TRAFFIC MONITORING SITE

ORIGINATION FORM

Proposed Revisions to a Standard Plans Index
(Please provide all information — Incomplete forms will be returned)

Index Number: 695-001
Sheet Number (s): 1 through 7
Index Title: Traffic Monitoring Sites

CABINET LAYOUT DETAILS (Four Lanes or Less)

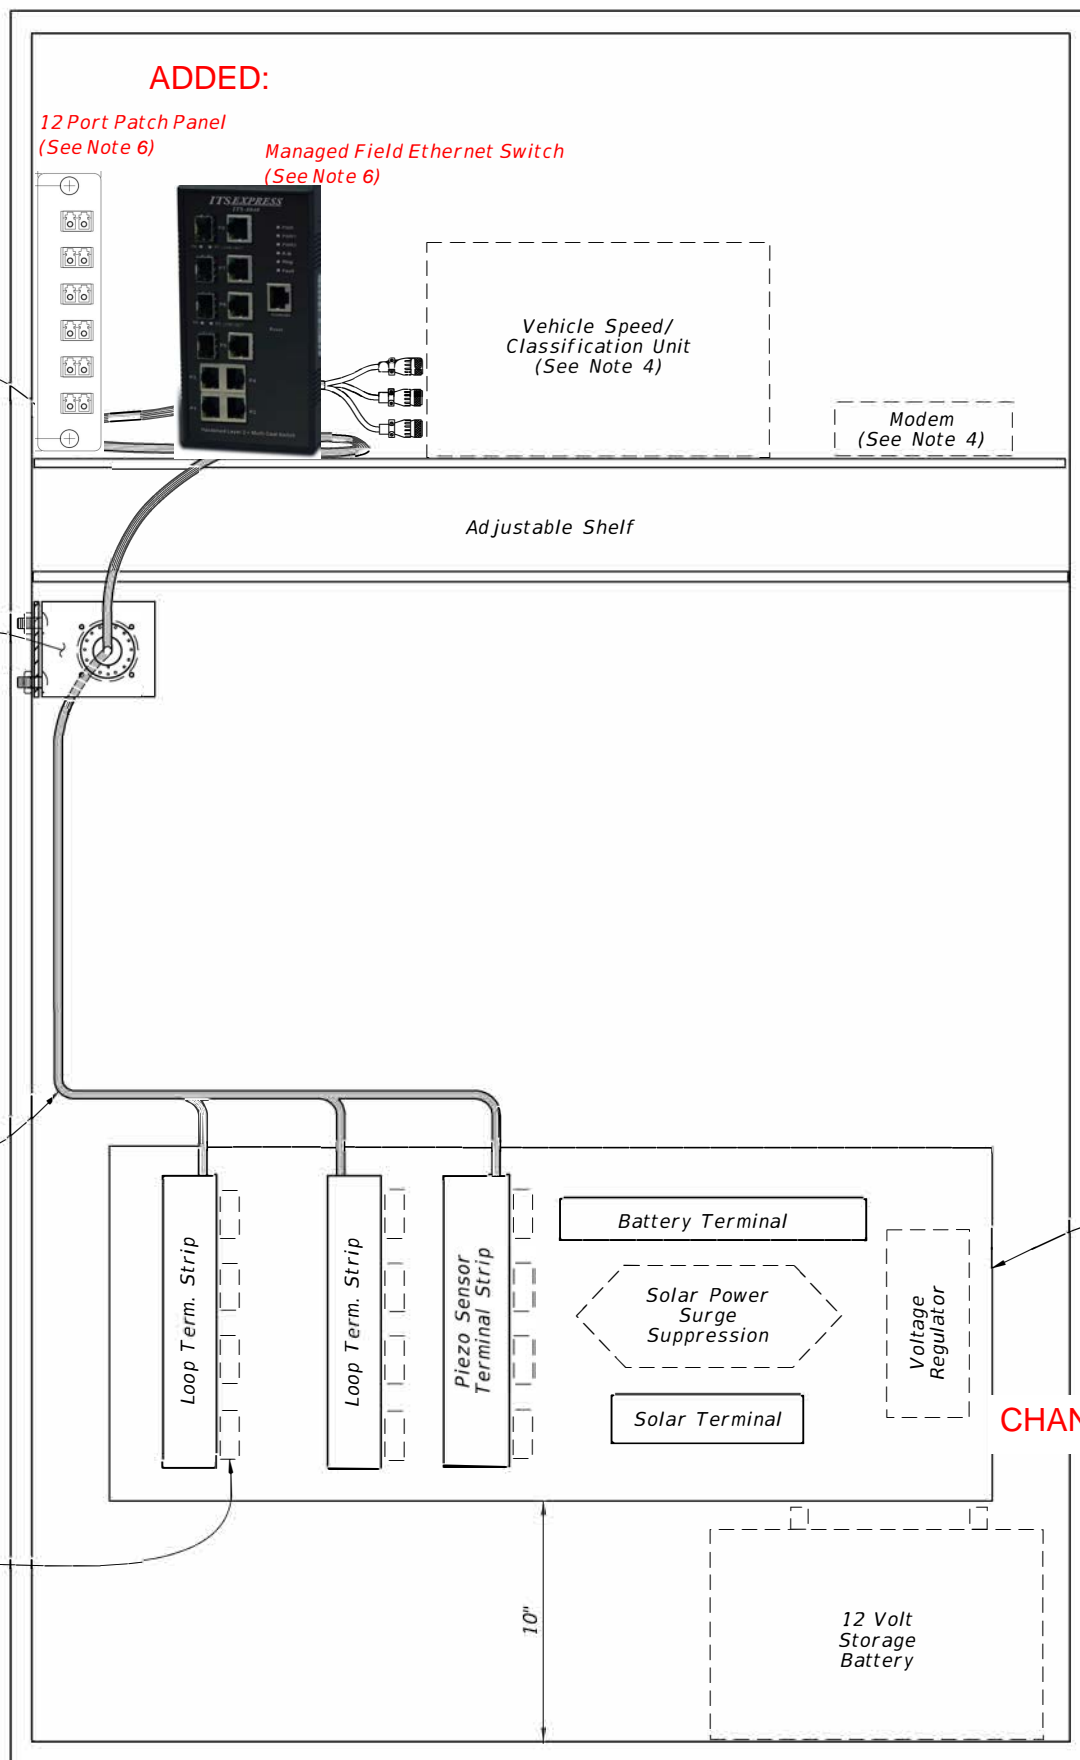
CHANGED TO: Data and Analytics

ADDED: Note 6

CABINET LAYOUT DETAILS (Five to Eight Lanes)

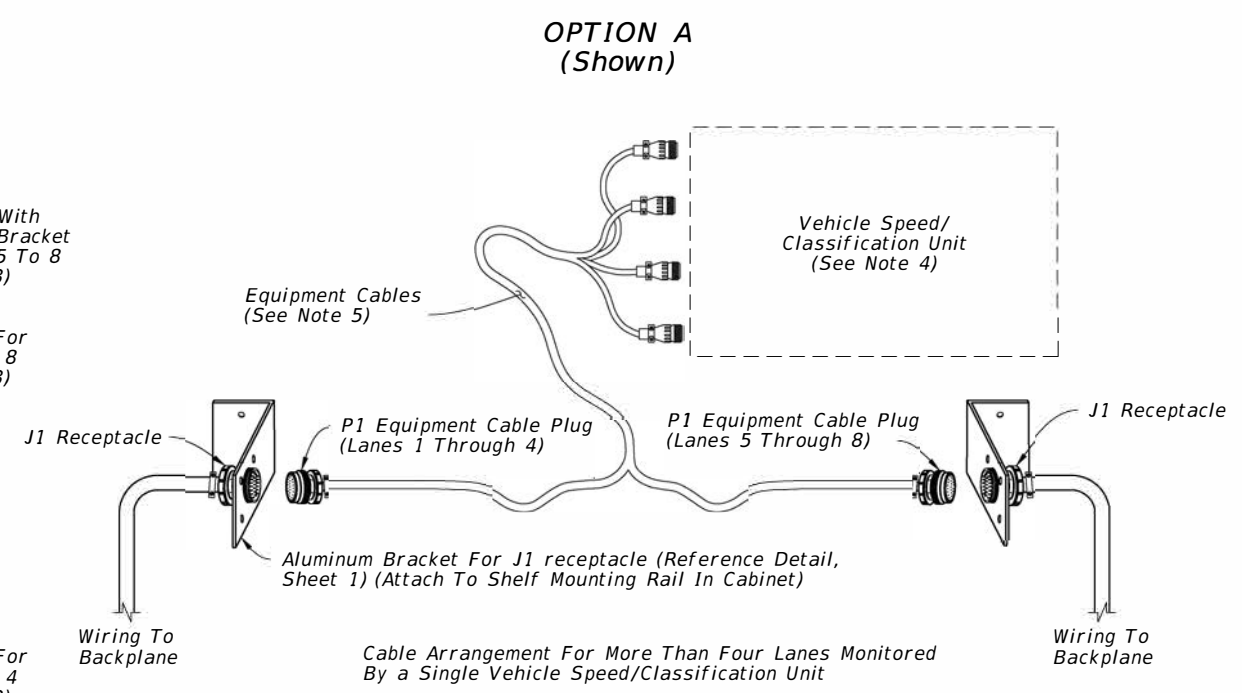
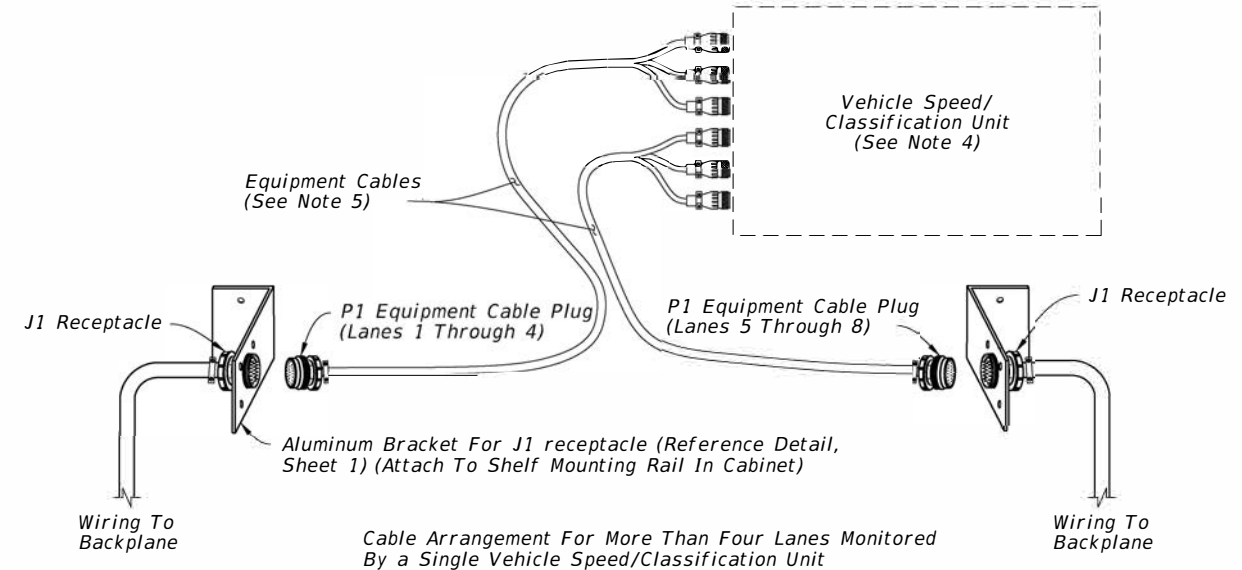
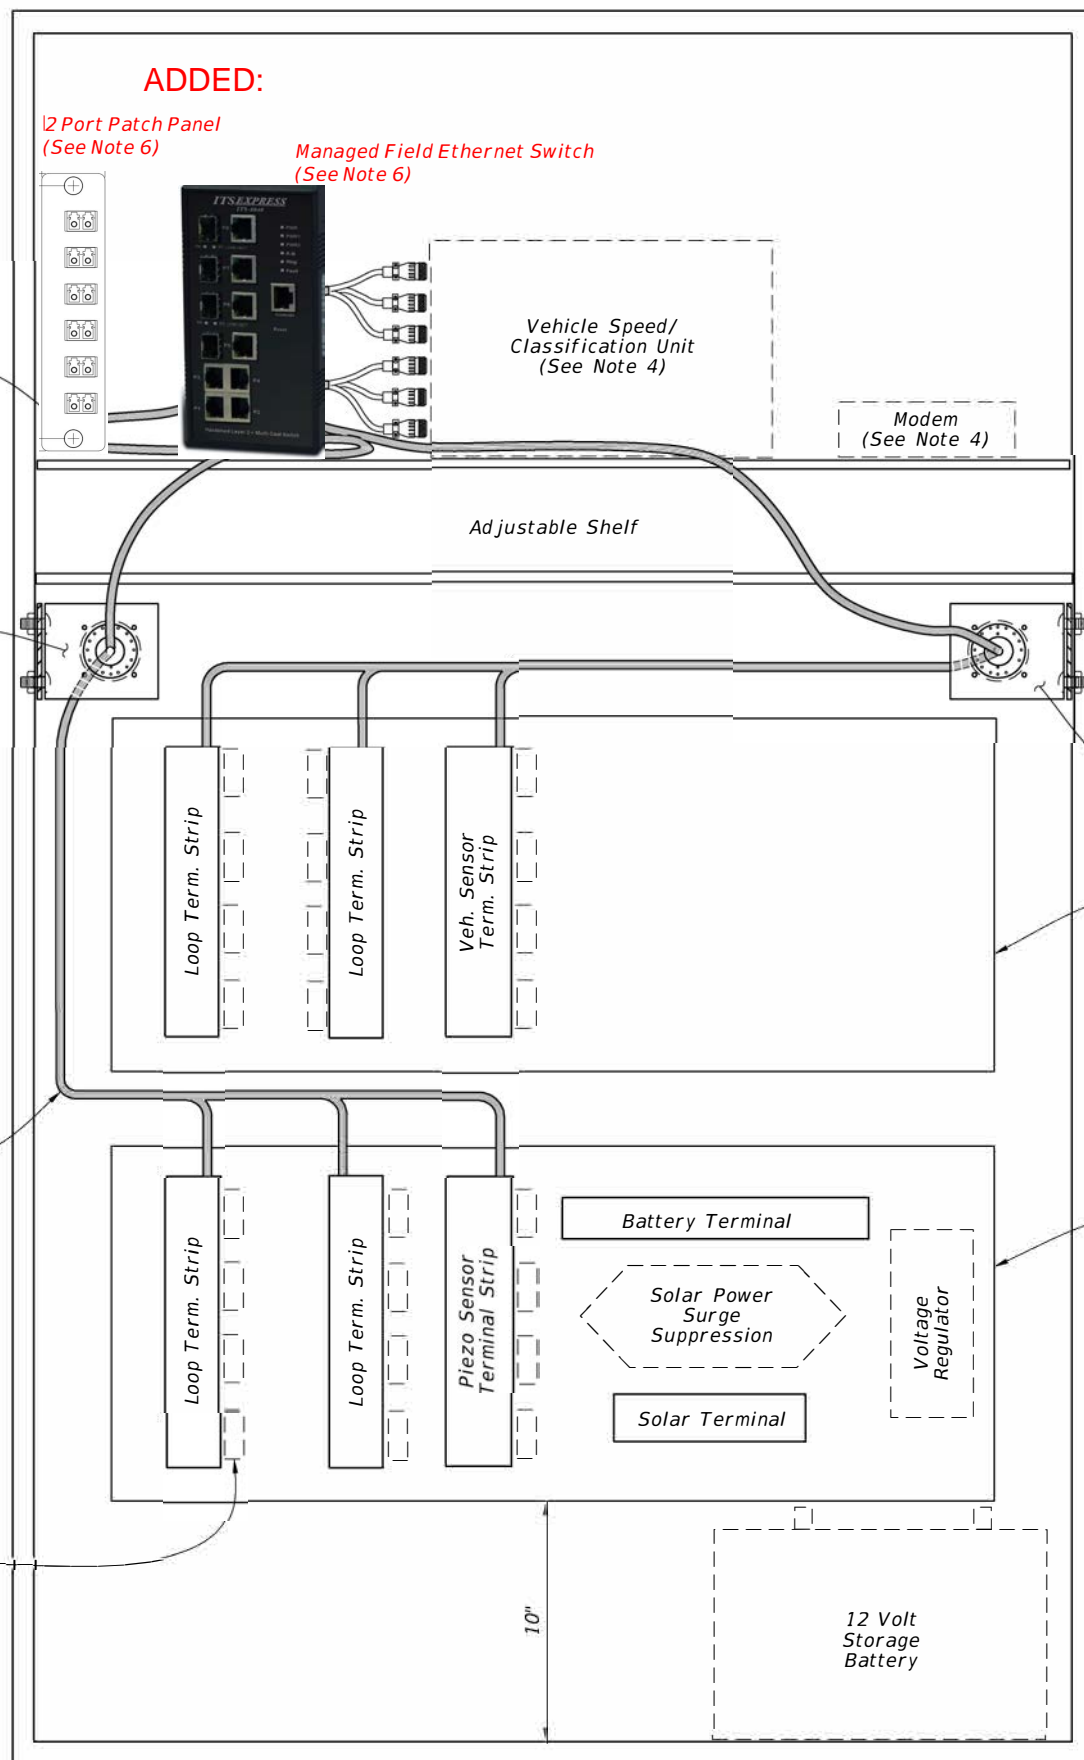
CHANGED TO: Data and Analytics

ADDED: Note 6

CABINET BACKPLANE DETAIL

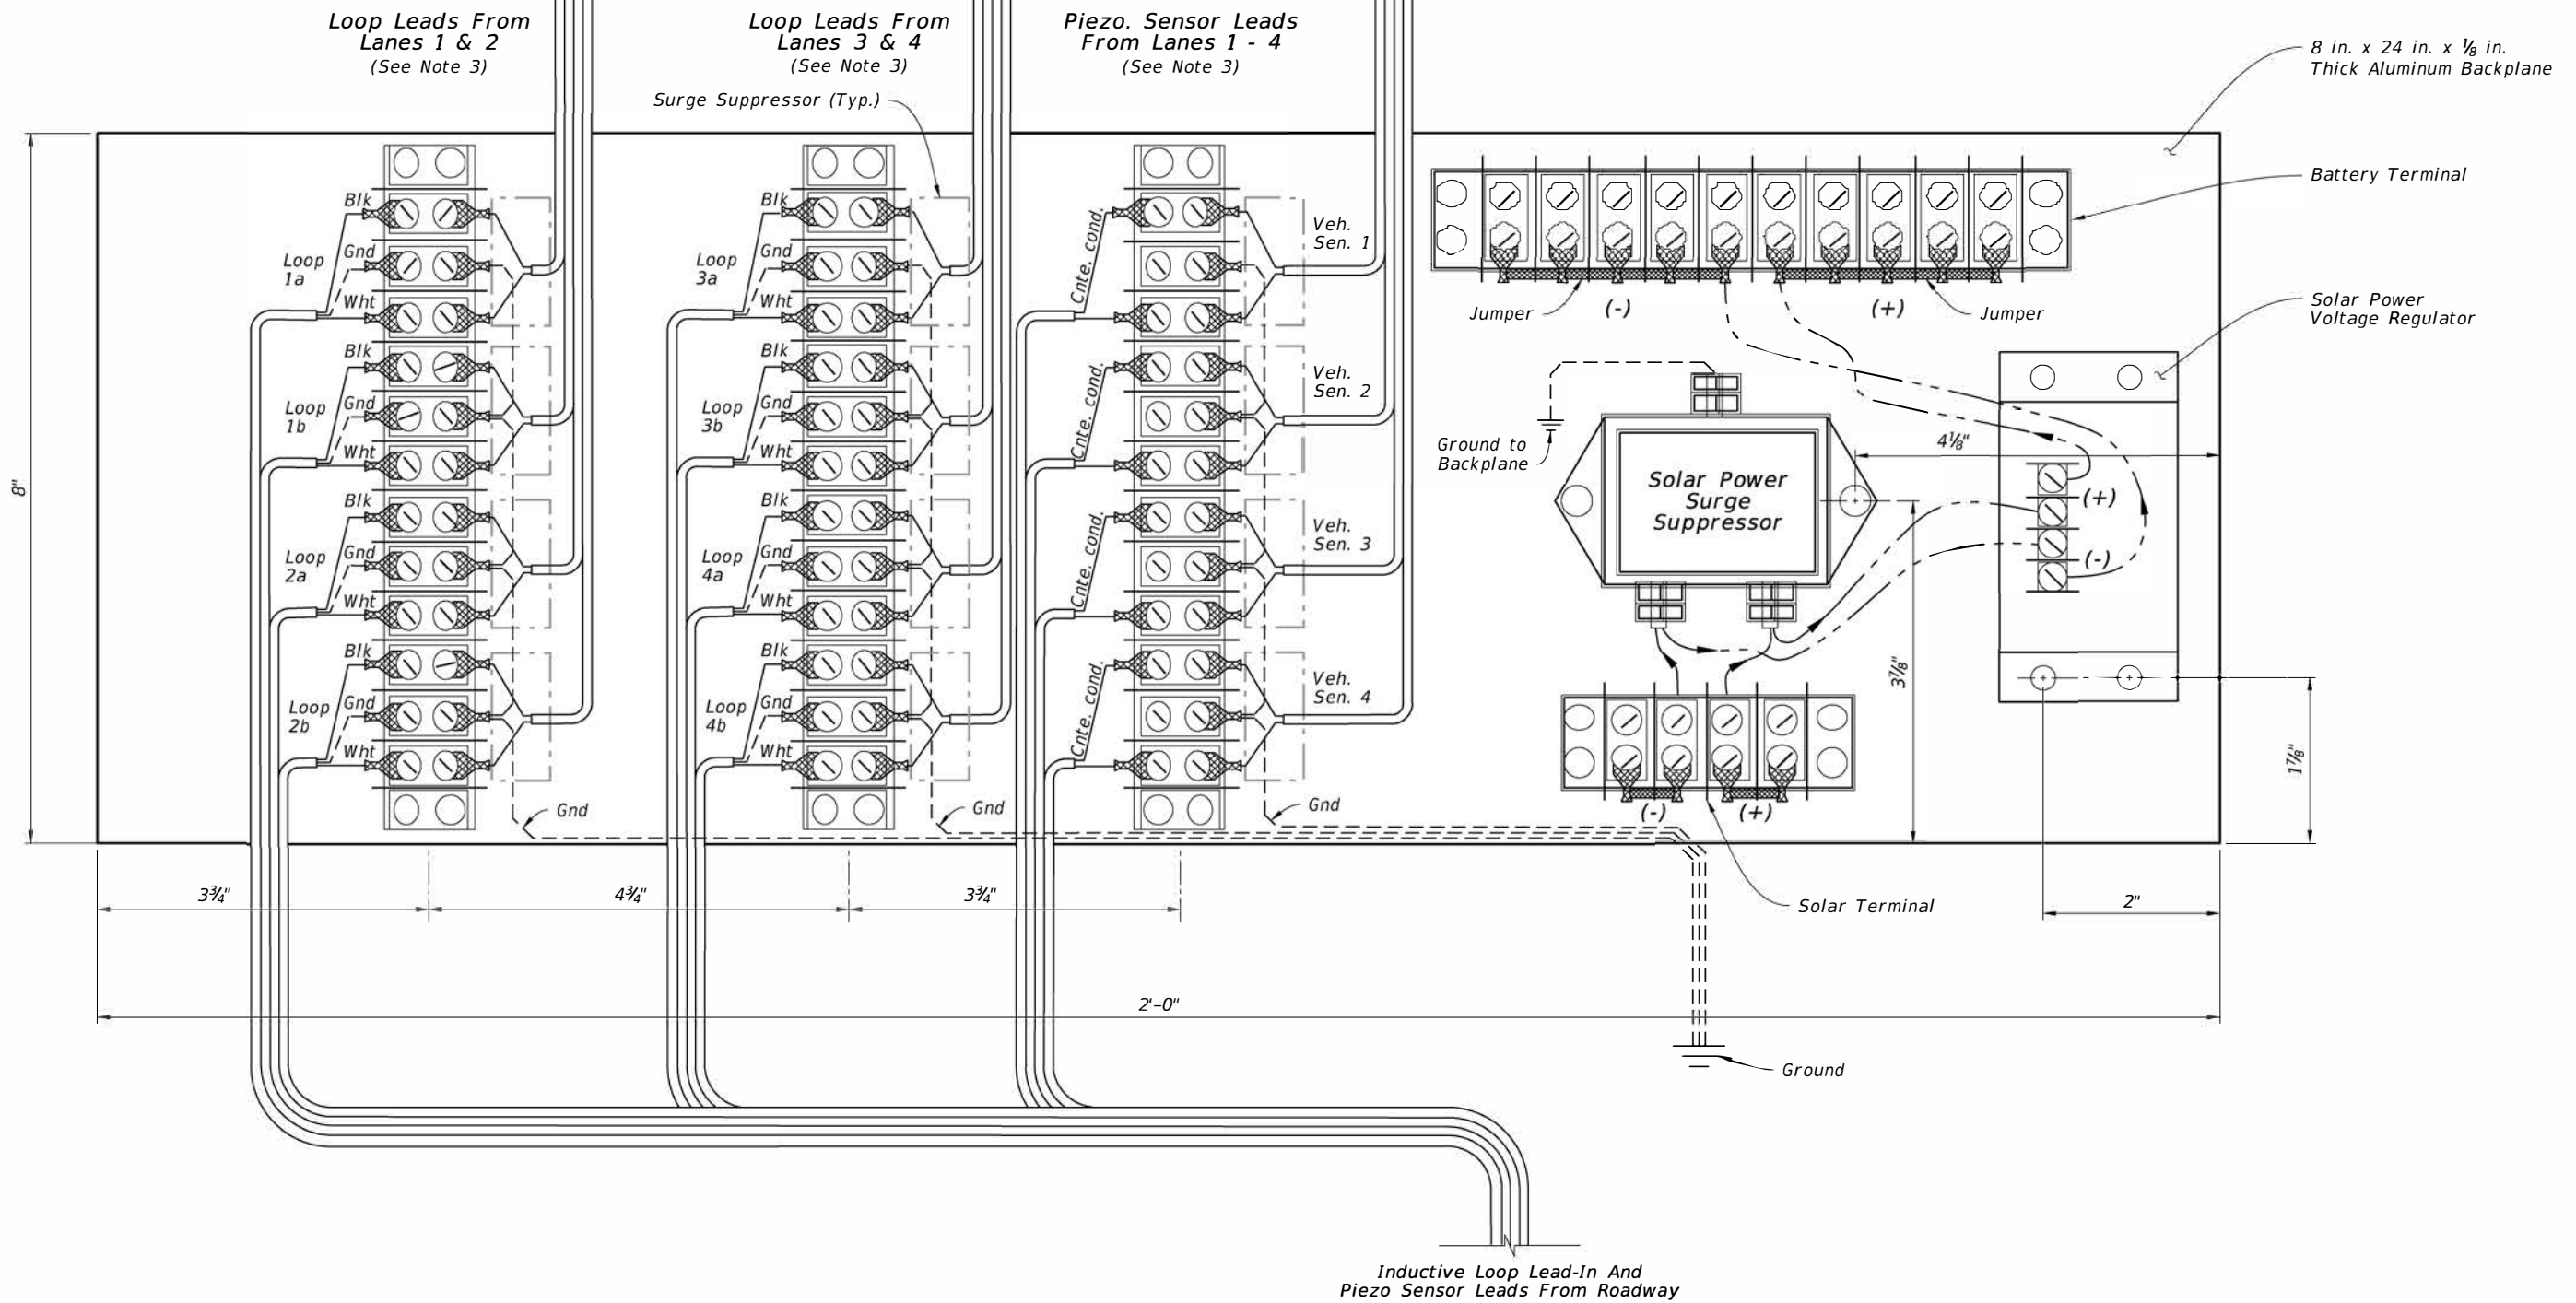
CHANGED TO: Data and Analytics

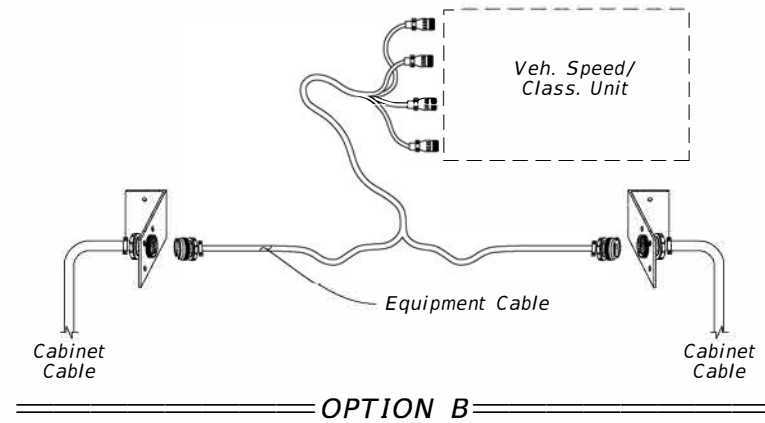
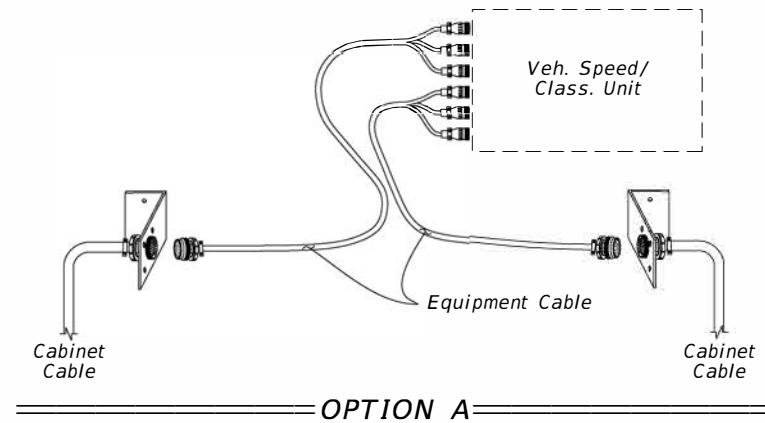
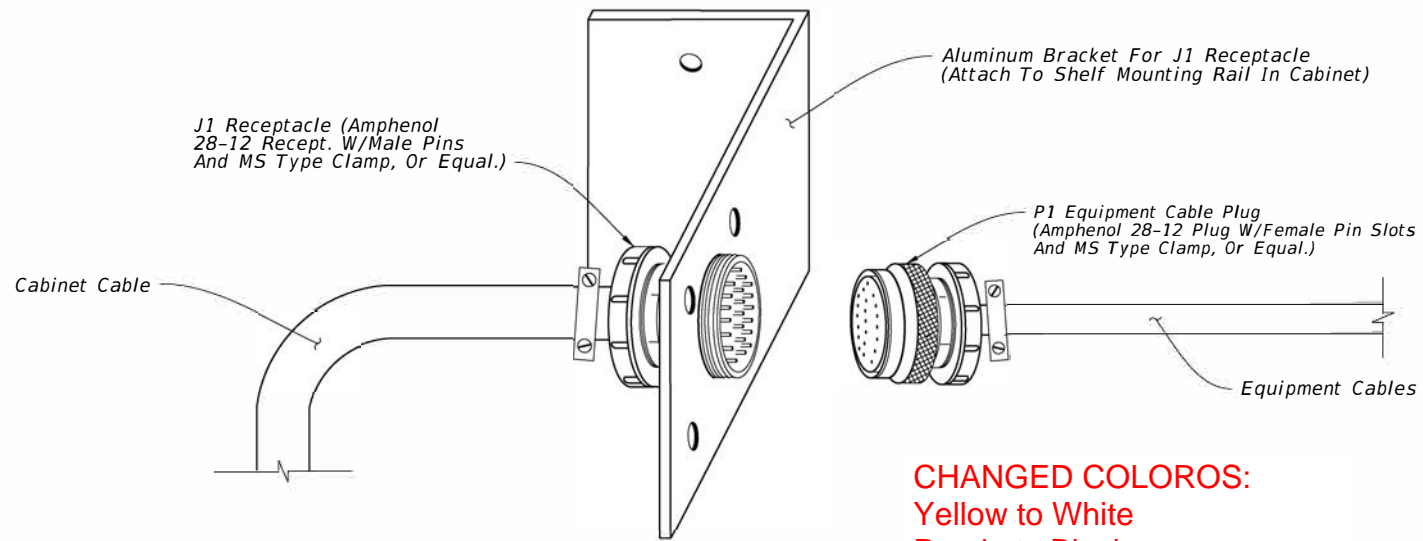
CHANGED COLOROS:
 Yellow to White
 Purple to Black
 Gray to Red
 Pink to Black
 Brown to Green

CHANGED TO: Data and Analytics

CHANGED TO: Green
